JABIRU AIRCRAFT PTY LTD

SERVICE BULLETIN: JSB 002-1

Subject: Jabiru J400 Elevator Drive Arm

Figure 1. Input Arm Comparison

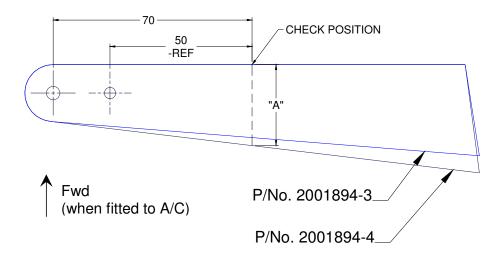
Referring to the Figure below, measure the input arm of the aircraft. Measure to a point on the forward edge (as oriented when fitted to the aircraft) of the arm 70mm (2.76") above the lower hole. At this check position, older type arms (P/No. 2001894-3) will be 25.6mm (1.01") wide, compared to 28.4mm (1.12") for the newer type arms (P/No. 2001894-4).

Figure 2 - Modification Procedure

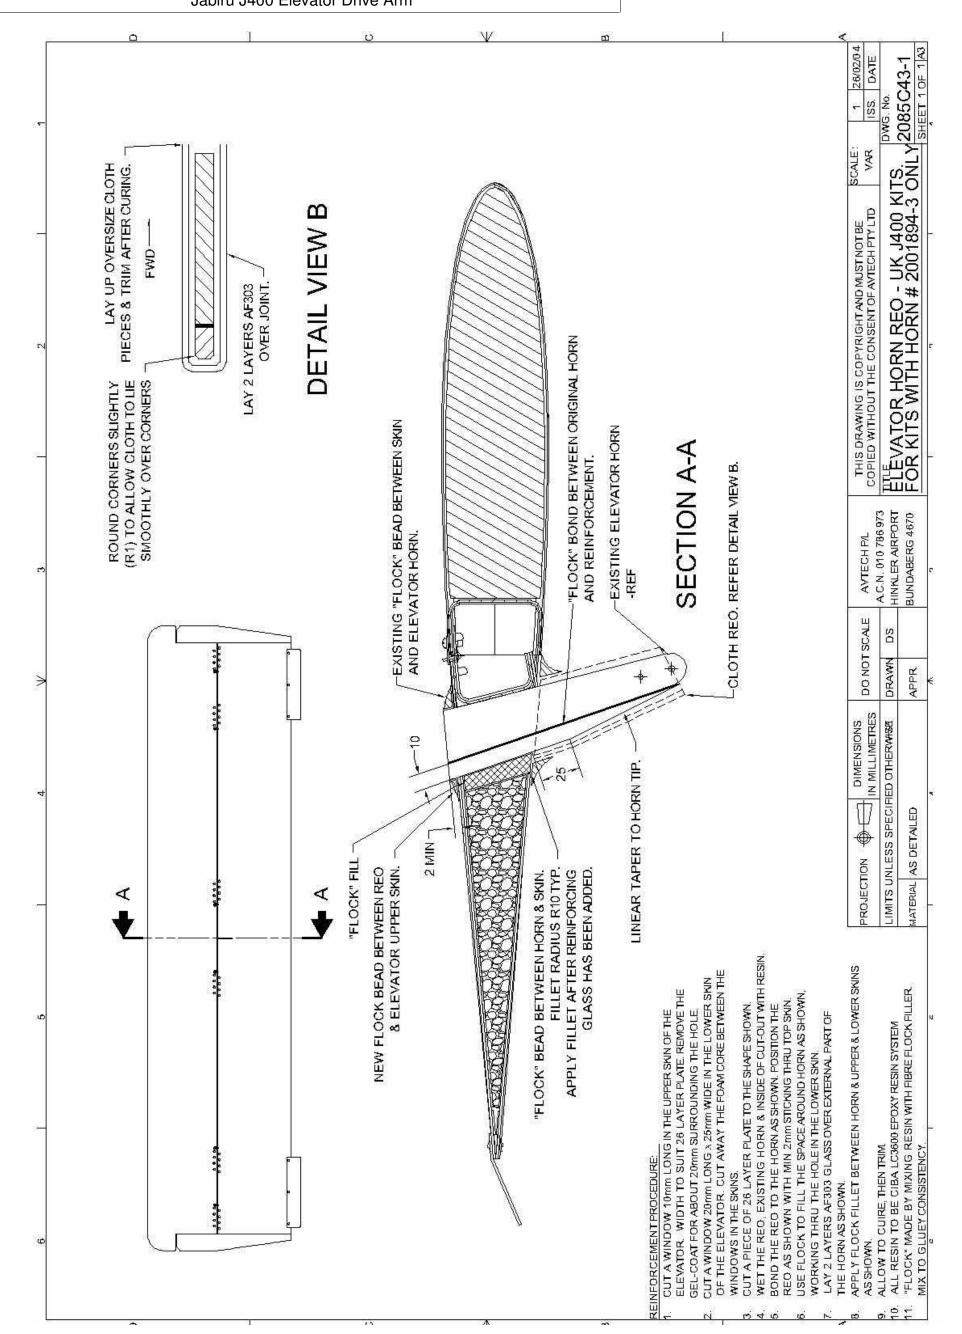
Aircraft with older style arms must be modified in accordance with the details given in Drawing 2085C43-1, included as Figure 2.
